SHEET NUMBER	SHEET NAME
GENERAL	
G000	COVERSHEET
G001	ENERGY CODE, LEAKAGE TESTING, & VENT CALCS
SURVEY	
S-1	TOPOGRAPHIC & BOUNDARY SURVEY
S-2	TOPOGRAPHIC & BOUNDARY SURVEY
ARCHITECTURAL DEMOLITION	
AD101	DEMOLITION SITE PLAN
AD102	DEMOLITION LOT COVERAGE SITE PLAN
CIVIL	
C100	TESC PLAN
C110	TESC DETAILS + NOTES
C200	TREE PLAN
C210	TREE DETAILS + NOTES
C300	CIVIL SITE PLAN
C310	CIVIL DETAILS + NOTES
C311	CIVIL DETAILS
SHORING	
AS101	ARCH. SHORING AND EXCAVATION SITE PLAN
AS111	EXCAVATION SITE SECTIONS
SH1.1	GENERAL SHORING NOTES
SH2.1	SHORING PLAN
SH3.1	SHORING DETAILS
SH4.1	SHORING ELEVATIONS
SH4.2	SHORING ELEVATIONS
ARCHITECTURAL	
A101	PROPOSED SITE PLAN
A102	SETBACK SITE PLAN
A103	PROPOSED LOT COVERAGE SITE PLAN
A104	SHORELINE REST. & TREE RETENT. / REPL. PLAN
A105	ENLARGED SHORELINE PLANTING PLAN
A211	LOWER FLOOR PLAN
A212	MAIN FLOOR PLAN
A213	ROOF PLAN
A301	EXTERIOR ELEVATIONS (N&E)
A302	EXTERIOR ELEVATIONS (S&W)
A401	BUILDING SECTIONS

SCOPE OF CHANGES:
• ROOF STORMWATER DRAINAGE CHANGE FROM SHEET DRAINAGE & HARDPIPED TRENCH SYSTEM TO GUTTER/DOWNSPOUT TIGHTLINED DRAINAGE SYSTEM. OVERALL UNDERGROUND HARDPIPED DRAINAGE SYSTEM REMAINS.
• ADDITION OF TRASH ENCLOSURE
• NEW WATER M

TESC PLAN

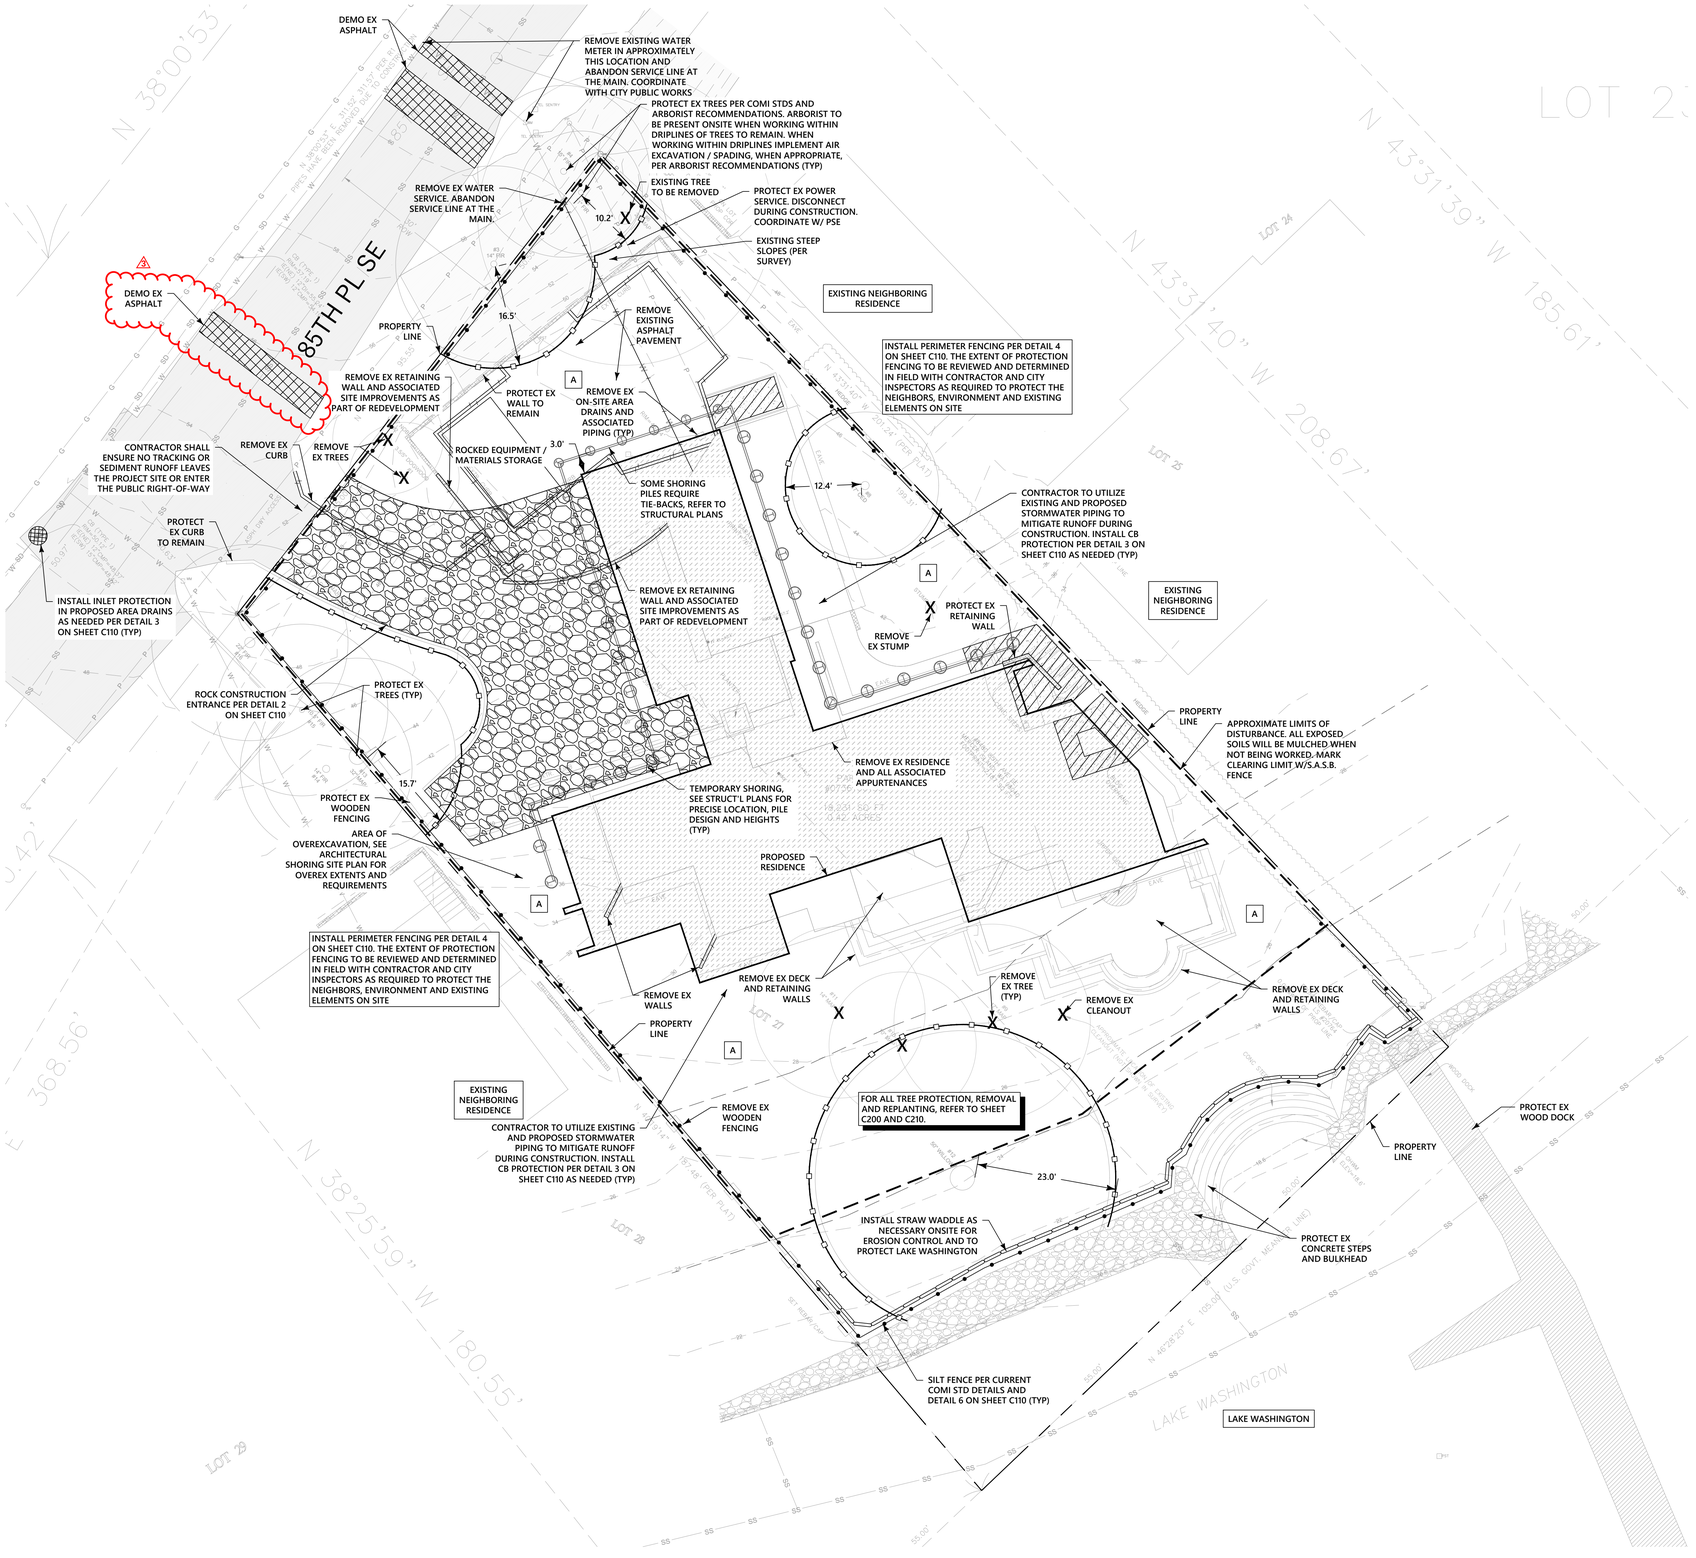
SCOPE OF CHANGES:
•NEW WATER METER LOCATION AS APPROVED BY PUBLIC WORKS VIA EMAIL

1 SITE PLAN
1" = 10'-0"

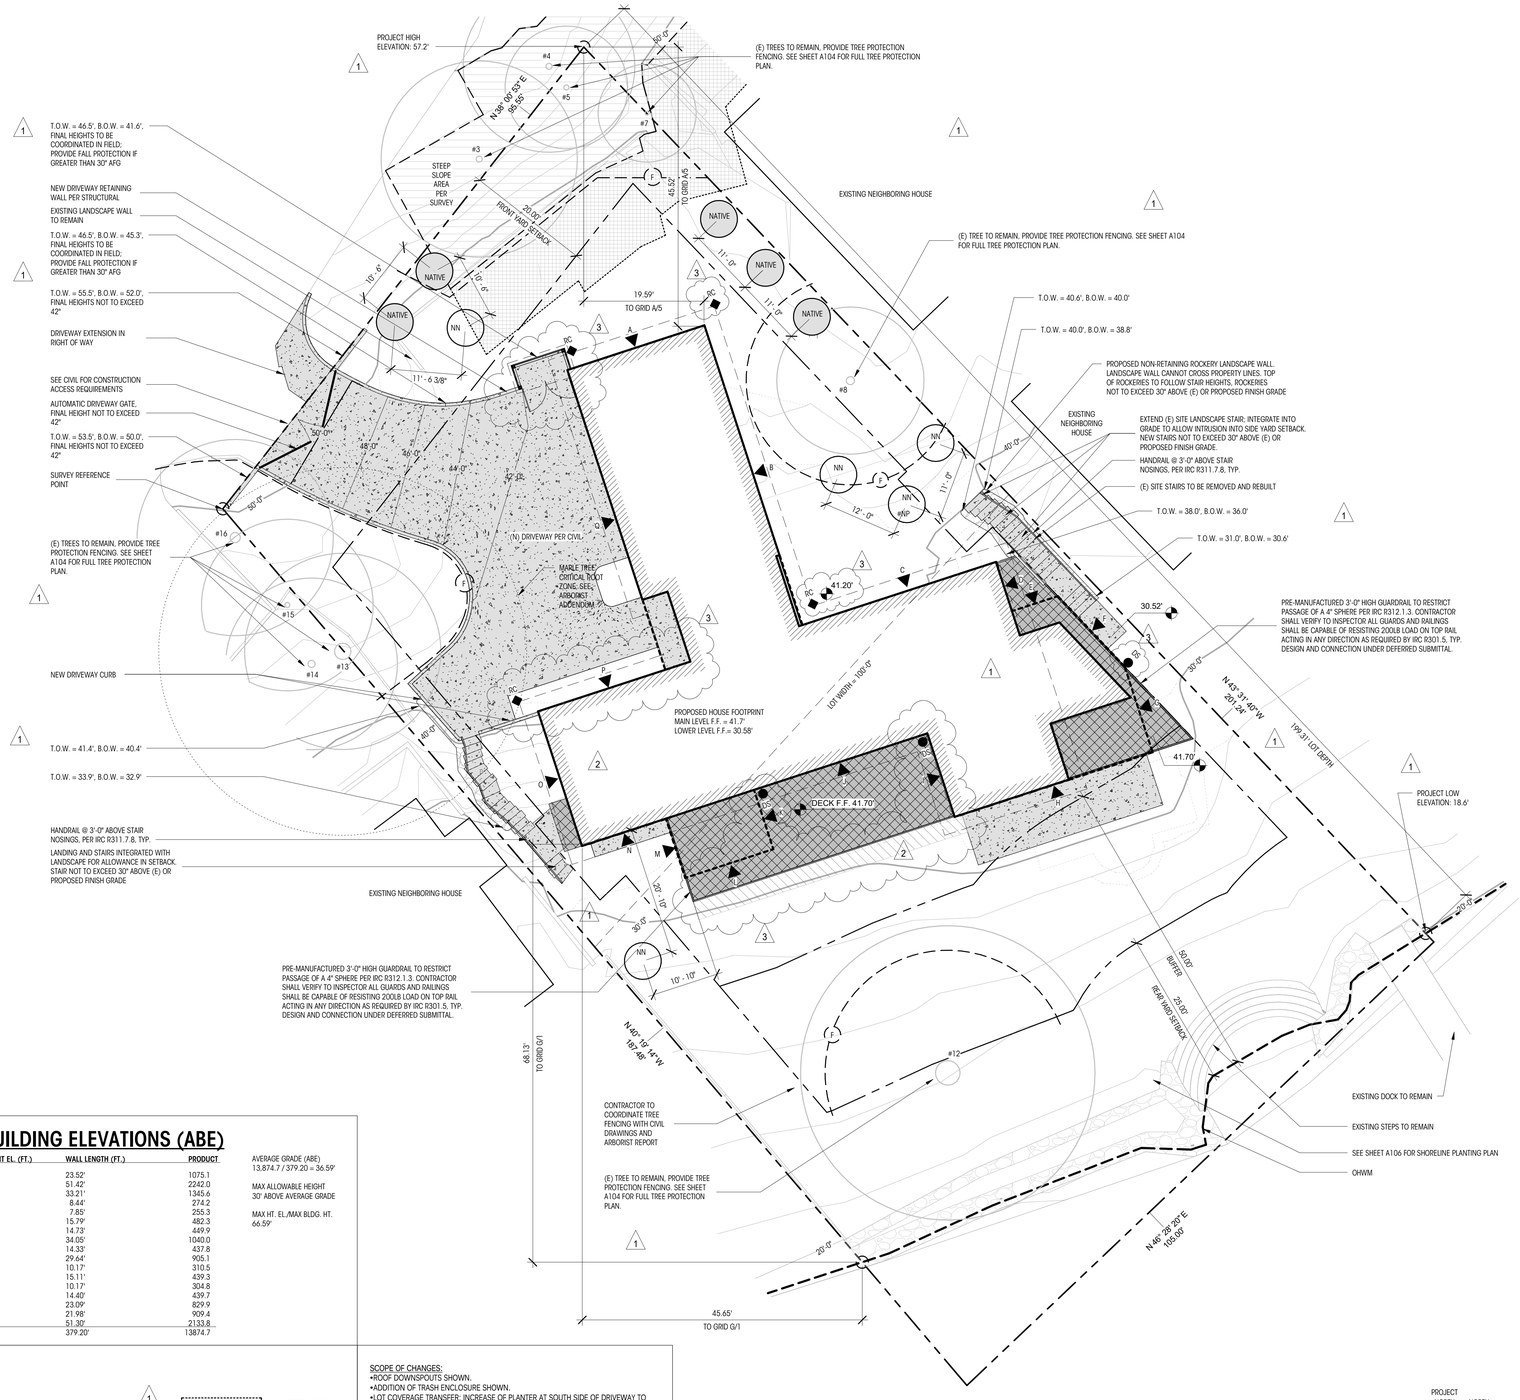
SCOPE OF CHANGES:
- ROOF DOWNSPOUTS SHOWN.
- ADDITION OF TRASH ENCLOSURE SHOWN.
- LOT COVERAGE TRANSFER; INCREASE OF PLANTER AT SOUTH SIDE OF DRIVEWAY TO ACCOUNT FOR TRASH ENCLOSURE COVERAGE.
- NO CHANGE OF GFA, HARDSCAPE, FOOTPRINT OR EXTENT OF ROOF OVERHANG.

1 SITE PLAN - SETBACK PLAN
1" = 10'-0"

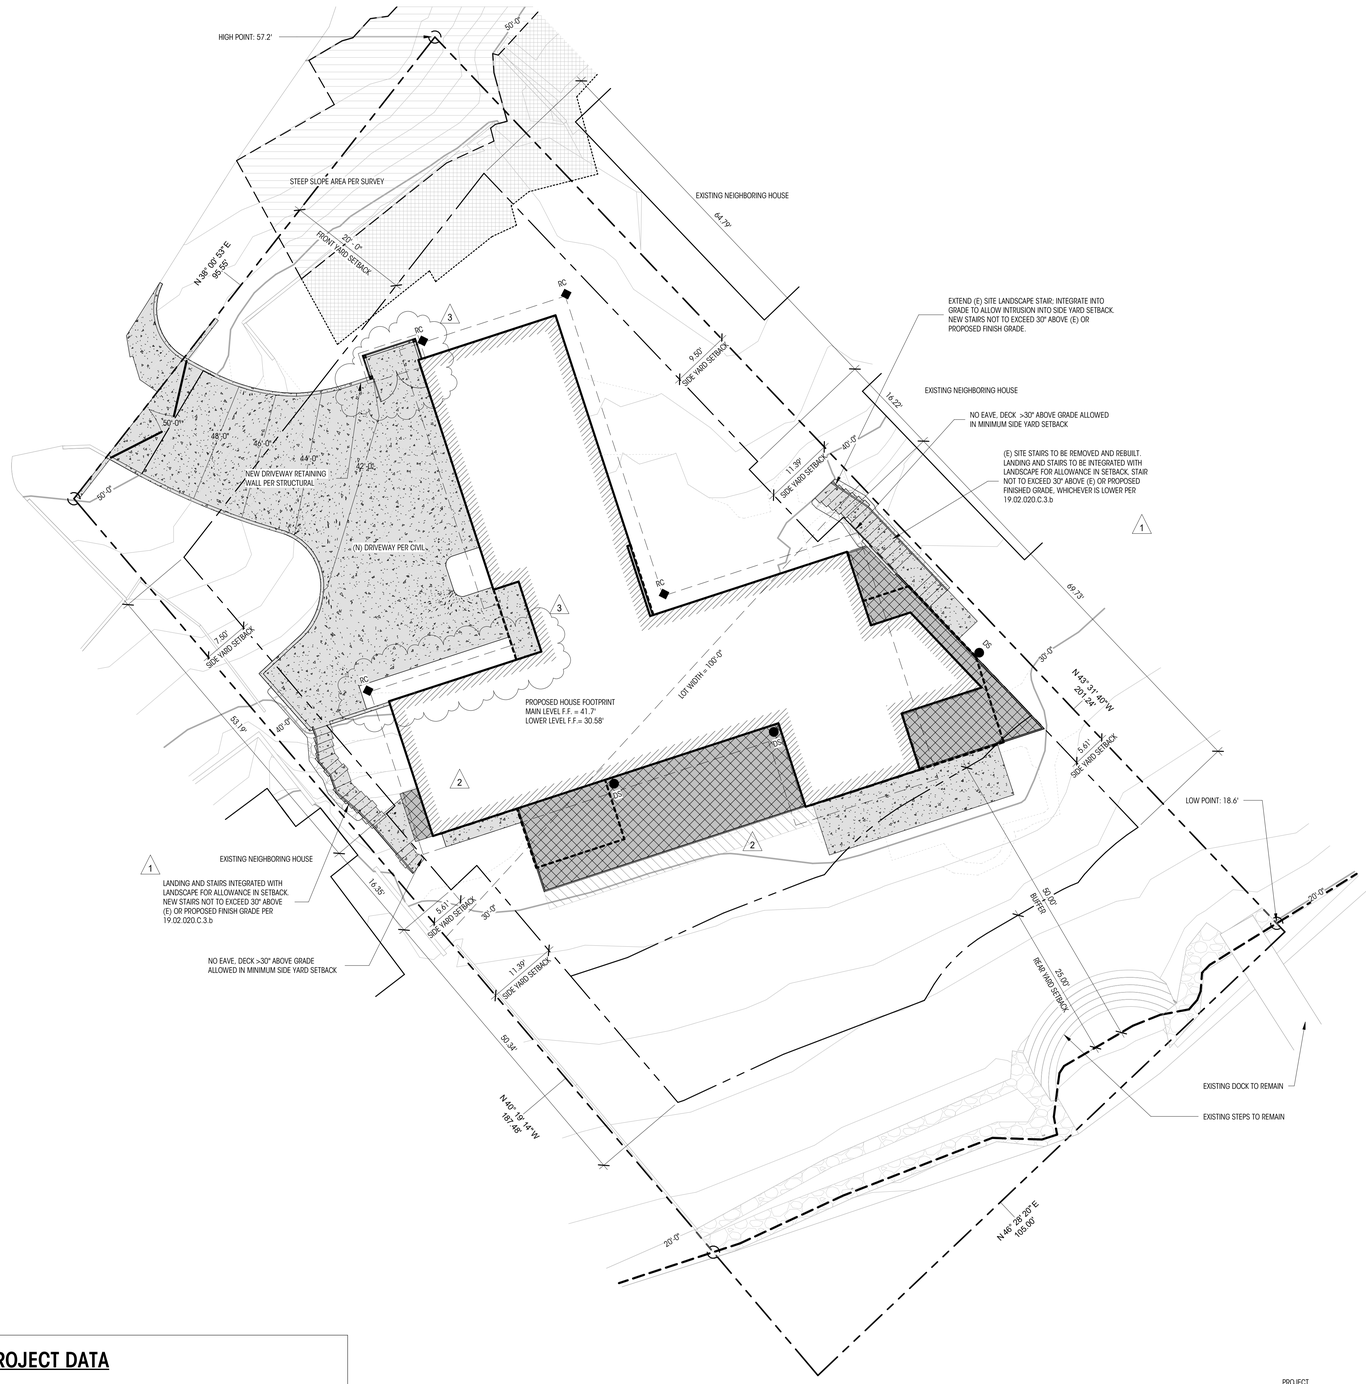
SCOPE OF CHANGES:
•NO CHANGES TO SETBACKS, PROXIMITY OF BUILDING TO SETBACKS.
•NO CHANGE OF GFA, HARDSCAPE, FOOTPRINT OR EXTENT OF ROOF OVERHANG.
•ROOF DOWNSPOUTS SHOWN.
•ADDITION OF TRASH ENCLOSURE SHOWN.
•LOT COVERAGE TRANSFER; INCREASE OF PLANTER AT SOUTH SIDE OF DRIVEWAY TO ACCOUNT FOR TRASH ENCLOSURE COVERAGE SHOWN.

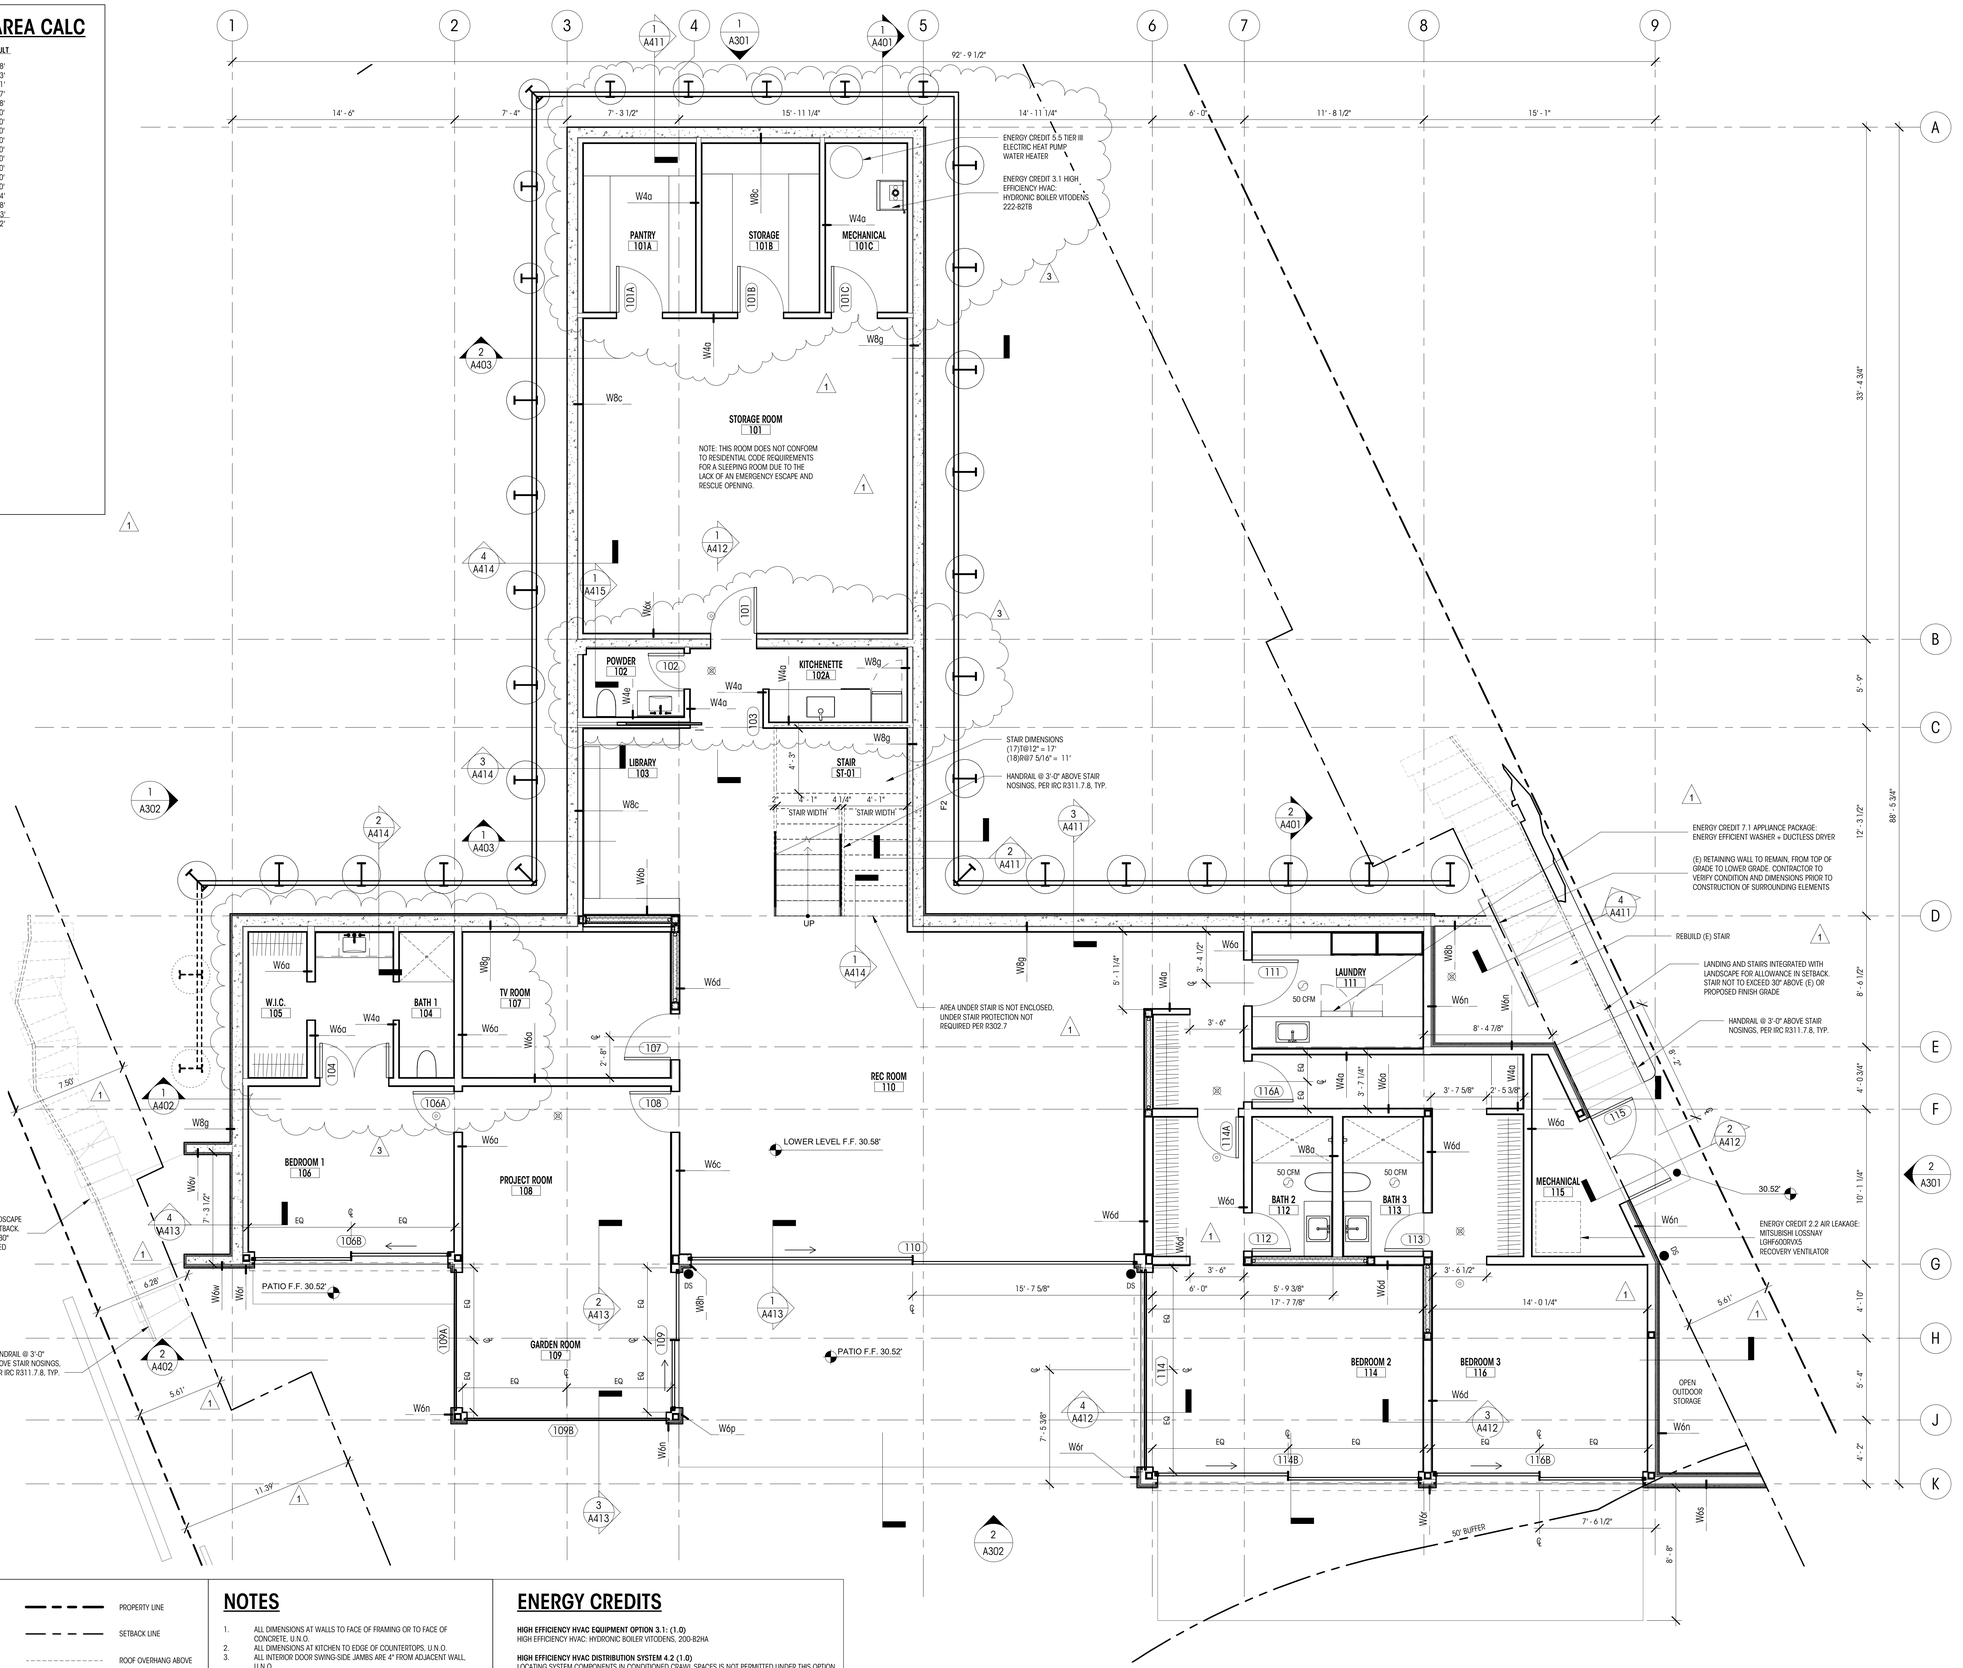
SCOPE OF CHANGES:
- BOILER LOCATION SHIFT FROM MECHANICAL ROOM ON EASTERN SIDE OF BUILDING TO ADDED MECHANICAL ROOM IN THE NE PORTION OF THE BASEMENT STORAGE SPACE.
- CHANGE TO ENERGY CREDITS
- SHIFT OF KITCHENETTE AND BATHROOM FROM WITHIN BASEMENT STORAGE AREA TO OUTSIDE OF STORAGE AREA.
- NO CHANGE OF GFA, HARDSCAPE, FOOTPRINT OR EXTENT OF ROOF OVERHANG.
